07.4—223 Renewing protective sleeves on injection valves

Installation survey (07.4—215).

- A Injection valve **without** protective sleeve
B Injection valve **with** protective sleeve

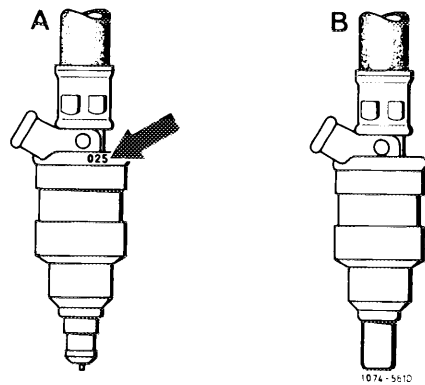
On engine 116, the color code has been changed from black to yellow.

Injection valves starting with production date 025 (arrow) can be subsequently provided with protective sleeves.

Due to the larger OD of the protective sleeve the ID of the rubber sealing ring has been increased. The modified rubber sealing ring can also be used on injection valves without protective sleeve.
